Subject: Interstate 4 from West of State Road 528 (Beachline) to West of State Road 435 (Kirkman Road) Value Engineering Study Recommendation Dispositions

FM: 242484-7

Value Engineering Study **Draft** Report

RECOMMENDATION No. 1: Use the FDOT property leased to OCCC for a pond to eliminate or minimize Pond 200B

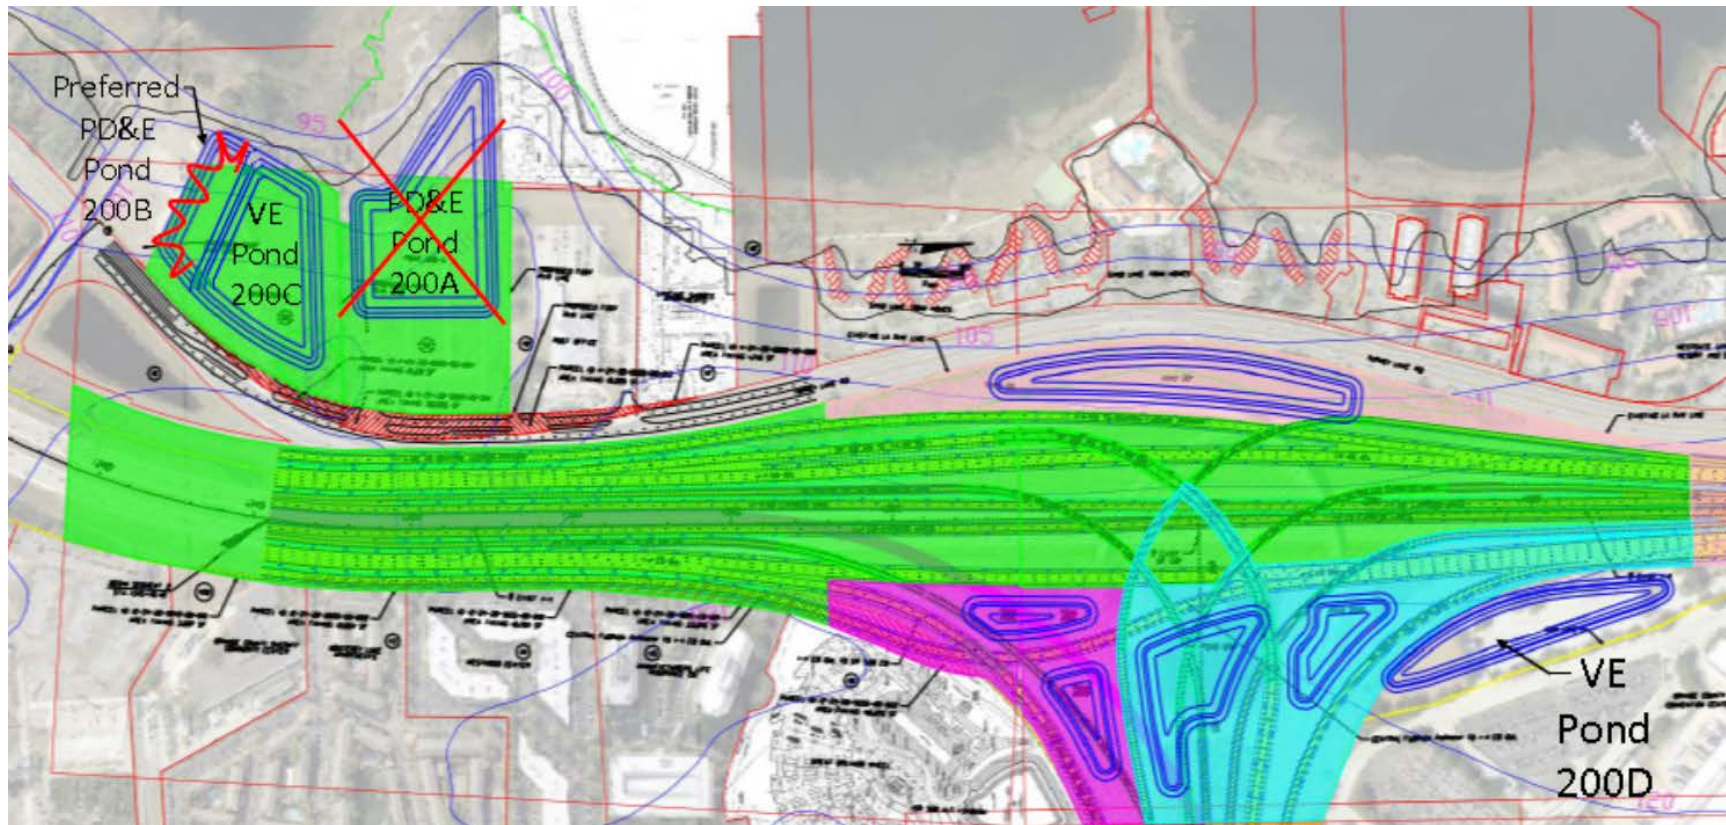
RECOMMENDATION No. 1: Use the FDOT property leased to OCCC for a pond to eliminate or minimize Pond 200B

The PD&E Documents show offsite Pond 200B on Parcel 80, at the beginning of Segment 2 and on the west side of I-4.

Reduce the size of Pond 200B by a third and provide the remainder of the needed stormwater storage in Pond 200D that is located within FDOT right-of-way in the northeast quadrant of the intersection of I-4 and SR 528. The land is currently being leased to the Orange County Convention Center and they are using it for parking.

Accepted. The FDOT property leased to OCCC will be converted to a proposed pond, which will result in either the elimination or minimization of Pond 200B.

RECOMMENDATION No. 2: North of Yogi Bear Campground use the residential lots to wrap a pond around the existing lake and create a joint use pond with Orange County

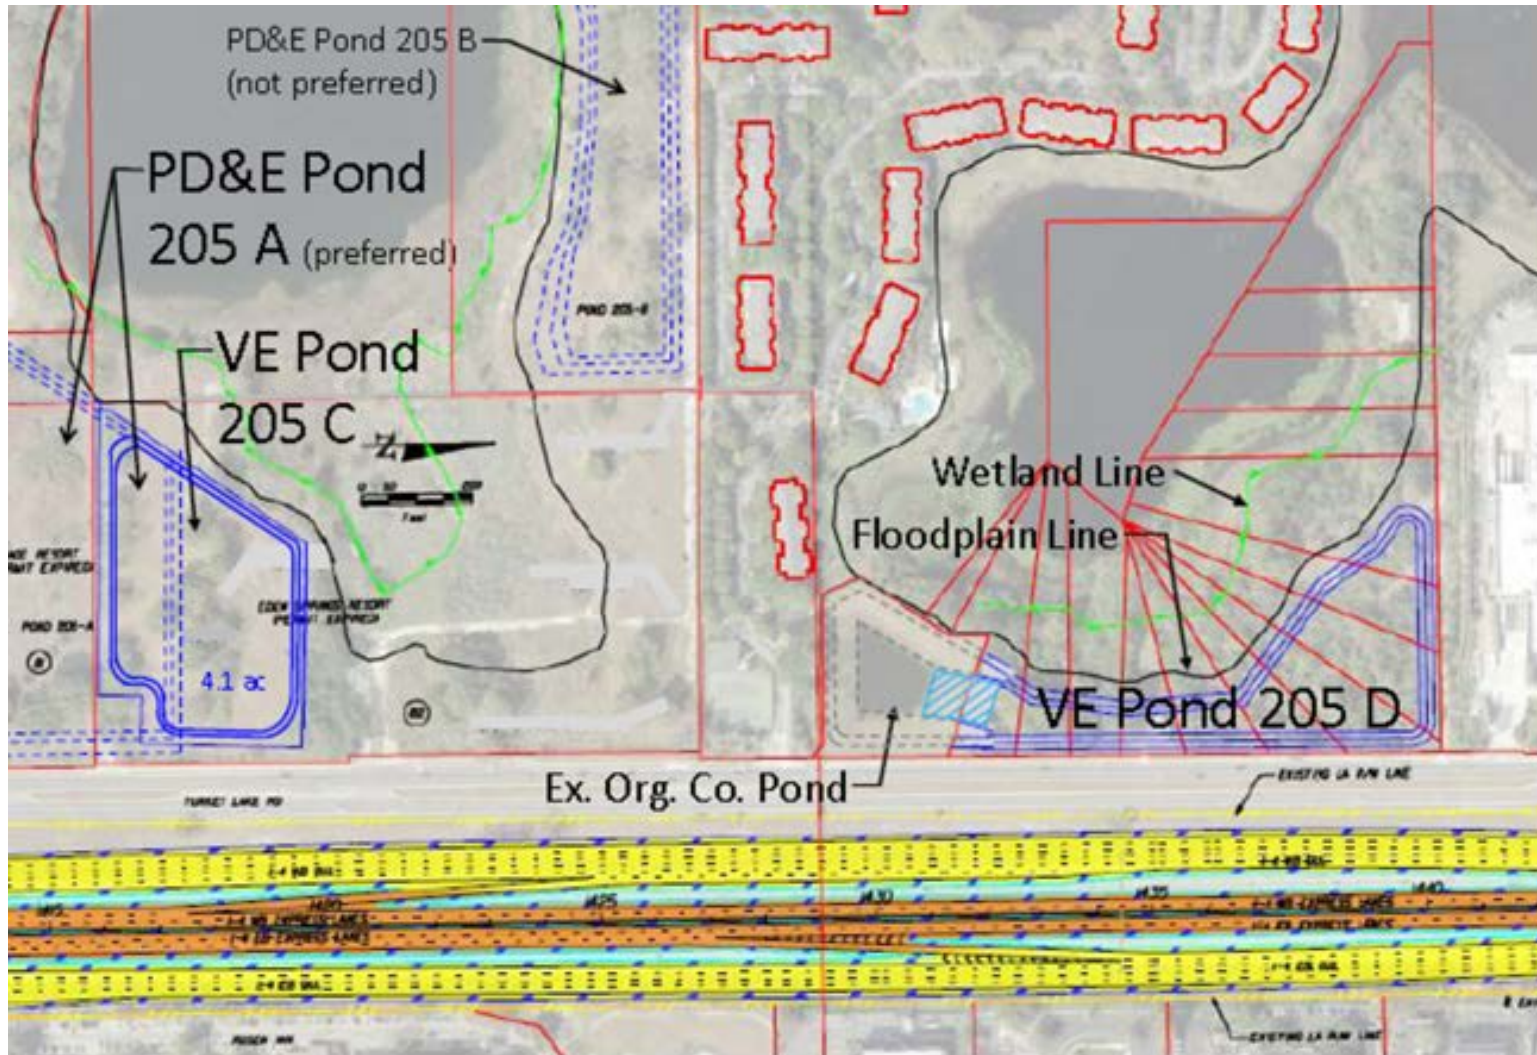
RECOMMENDATION No. 2: North of Yogi Bear Campground use the residential lots to wrap a pond around the existing lake and create a joint use pond with Orange County

The PD&E Documents show the preferred Pond 205A on assigned Parcel Numbers 81 and 82. Parcel 82 (formerly known as Yogi Bear Campground property) is located on the west side of Turkey Lake Road south of WalMart.

Construct a new Pond 205C on the Yogi Bear Campground property in conjunction with Pond 205D on the residential lots south of WalMart. Combine Pond 205D with the existing Orange County pond. An FDOT easement for an outfall into Big Sand Lake already exists.

Not accepted. Combining Pond 205D with the Orange County pond would lead to additional coordination with the county and only a very small amount of storage would be gained. The county pond is not designed to FDOT standards; therefore, the amount of storage that could be gained would be very small.

RECOMMENDATION No. 3: North of Yogi Bear Campground use the residential lots to wrap a pond around the existing lake as a stand-alone pond

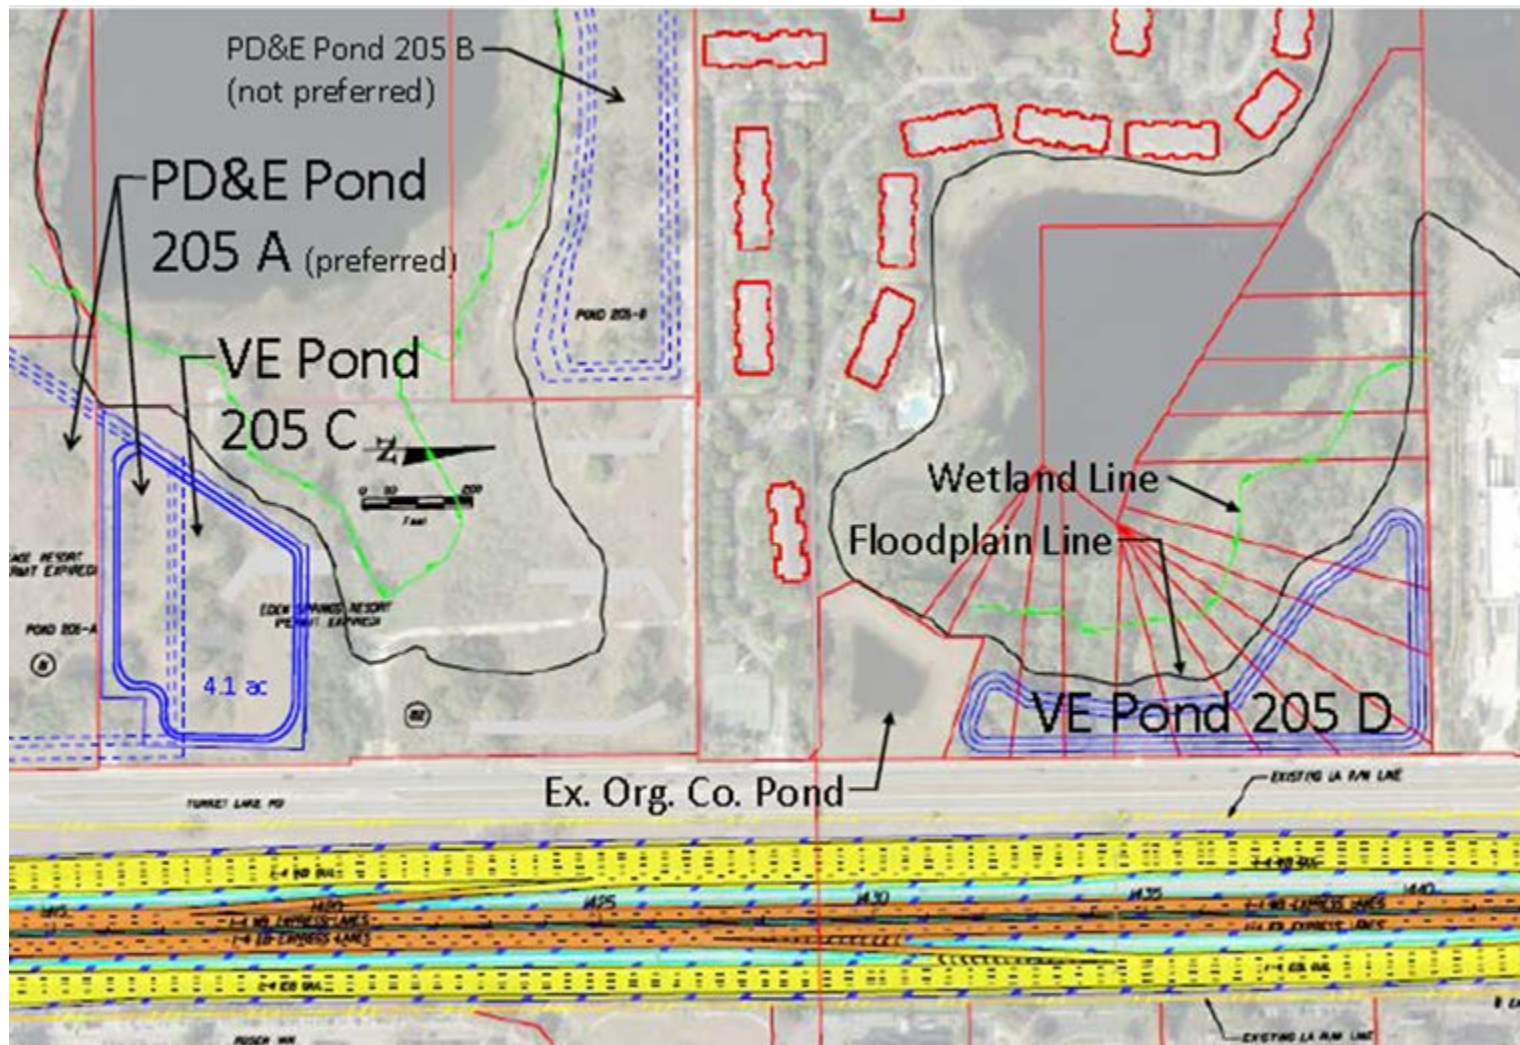
RECOMMENDATION No. 3: North of Yogi Bear Campground use the residential lots to wrap a pond around the existing lake as a stand-alone pond

The PD&E Documents show preferred pond is Pond 205A on assigned Parcel Number 81 and 82. Parcel 82 (formerly known as Yogi Bear Campground property) located on the west side of the road south of WalMart.

Construct a new Pond 205C on the Yogi Bear Campground property in conjunction with Pond 205D on the residential lots south of WalMart. Construct stand-alone Pond 205D. An FDOT easement for an outfall into Big Sand Lake already exists.

Accepted. A new Pond 205-D will be added on the residential lots south of WalMart and Pond 205-A will be shifted and renamed Pond 205-C to be used in conjunction with Pond 205-D. Pond 205-C will be located north of Pond 205-A and will only impact one property owner instead of two.

ALTERNATIVE 4 FOOTPRINT (SR 528)

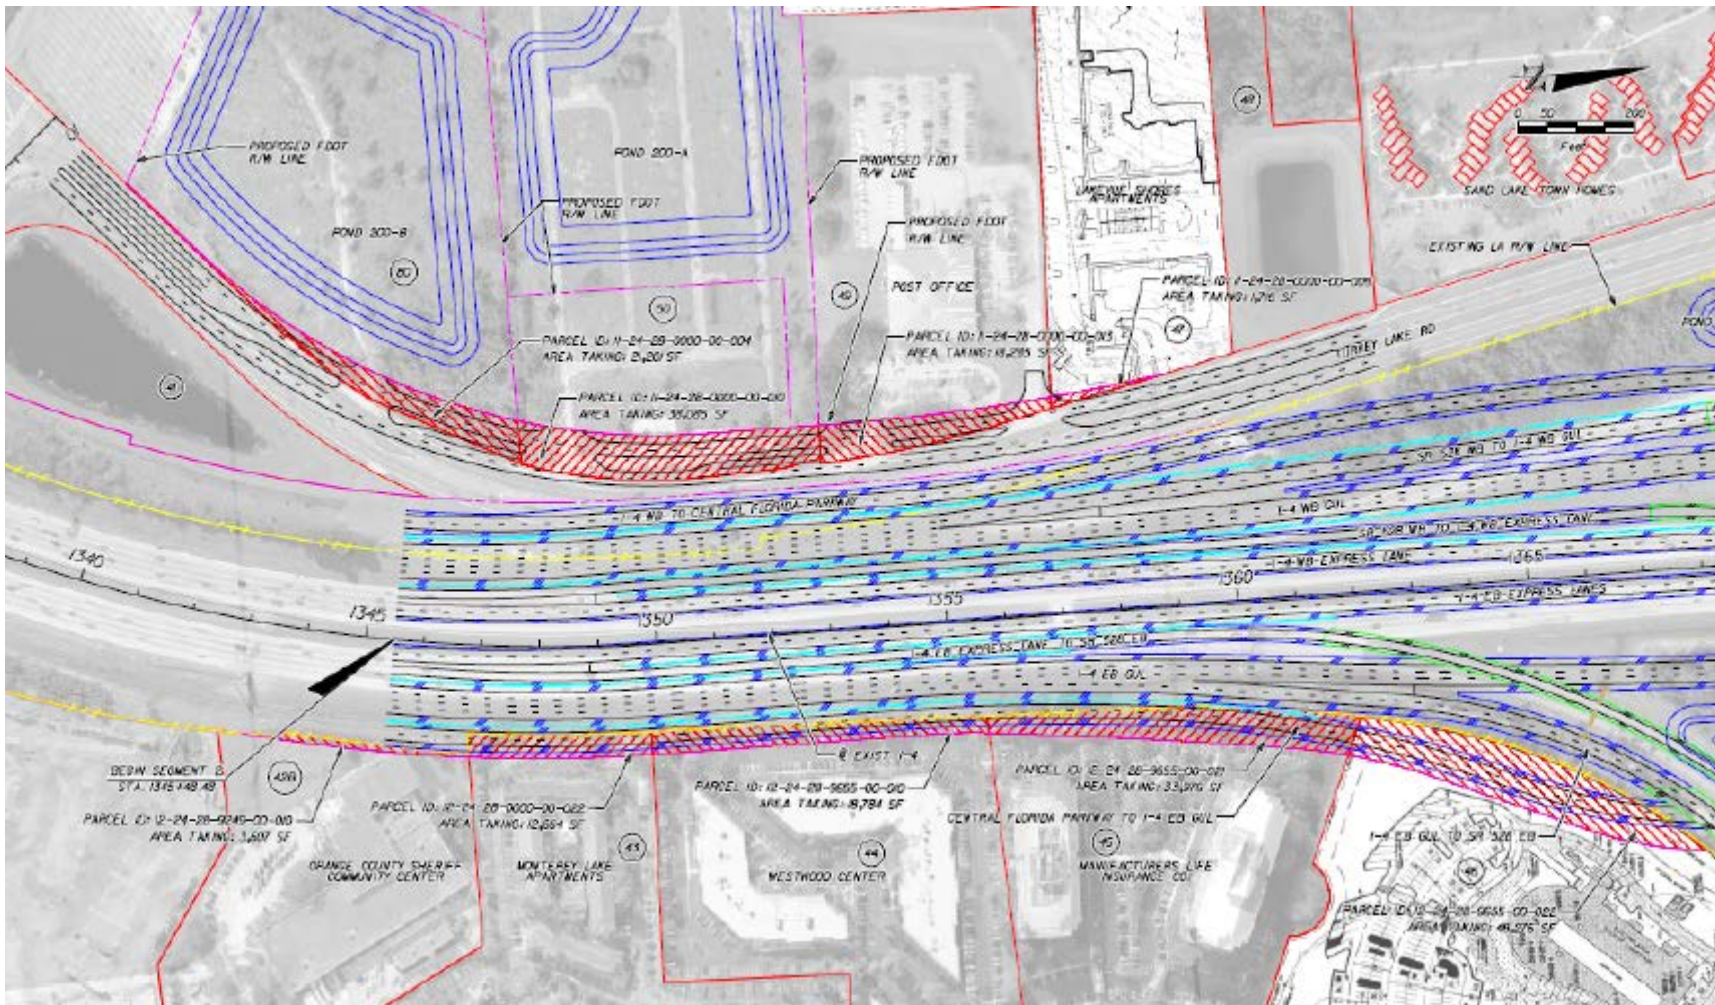
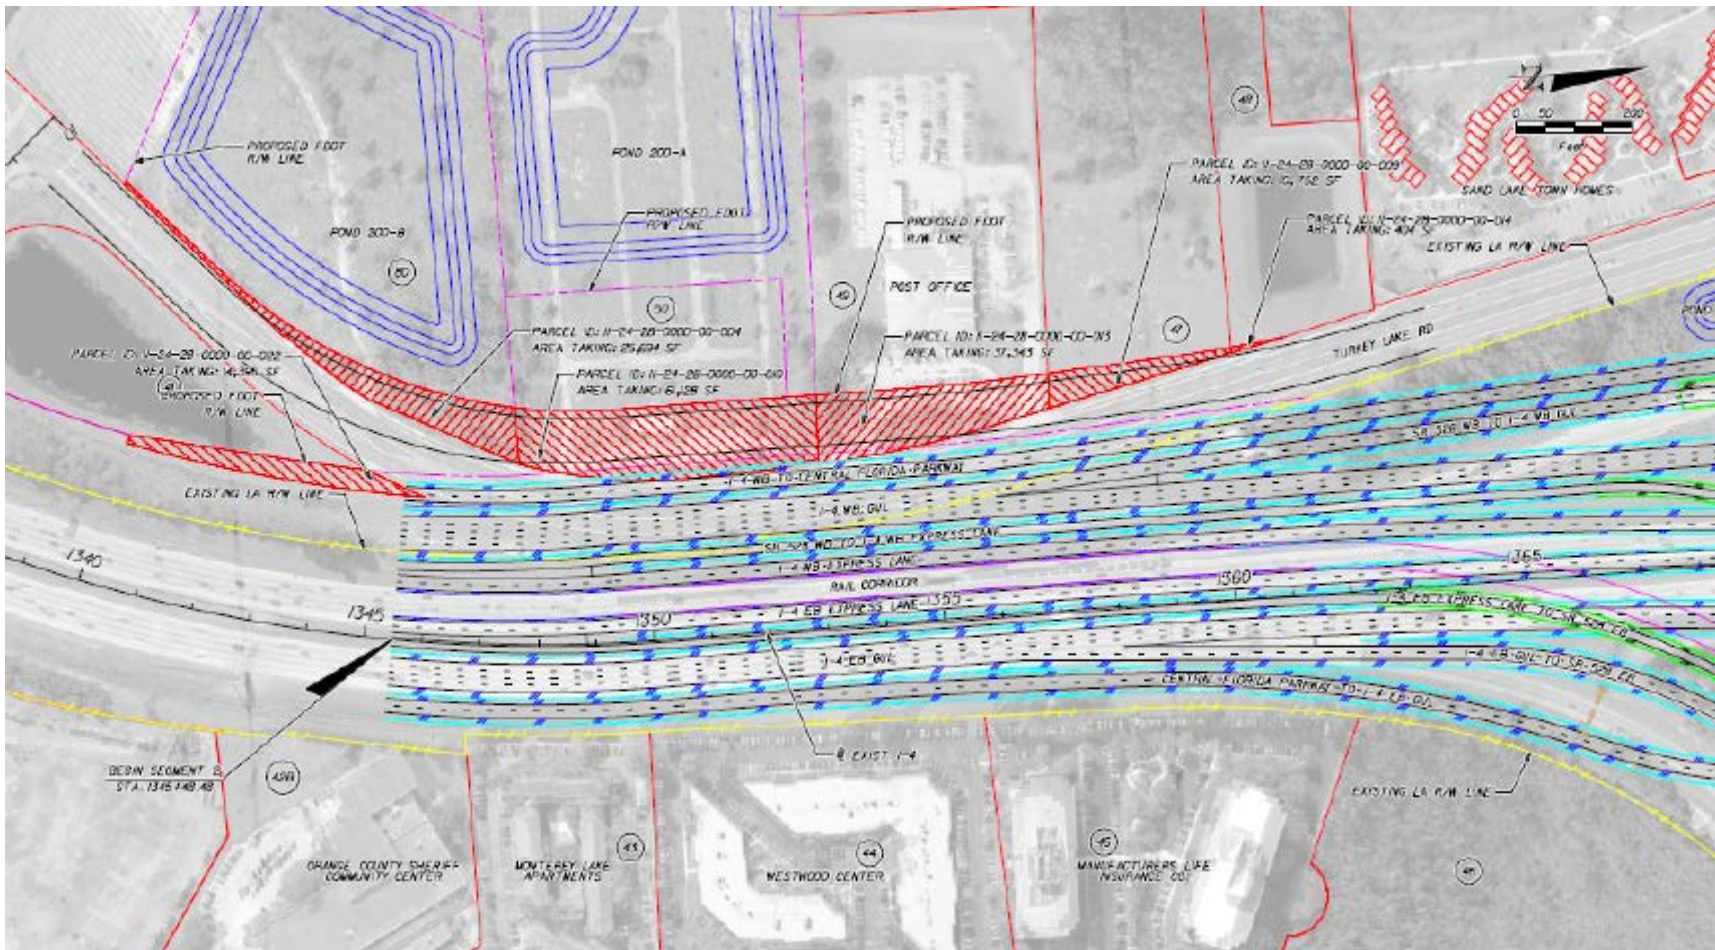
RECOMMENDATION No. 5: Avoid the east side right of way impacts by using Alternate 4 footprint at SR 528

The PD&E Documents shows for the SR 528 interchange Alternate 1, proposed right of way takes from five parcels located on the east side of I-4 and proposed right of way takes from four parcels located on the west side of I-4.

This recommendation is to realign the horizontal geometry of the SR 528 interchange pushing the overall footprint westward to eliminate all right of way takes on the east side of I-4 as shown in the SR 528 interchange Alternate 4 exhibit.

Accepted. Alternative 4 at SR 528 will be the preferred alternative in order to eliminate impacts to properties on the east side.
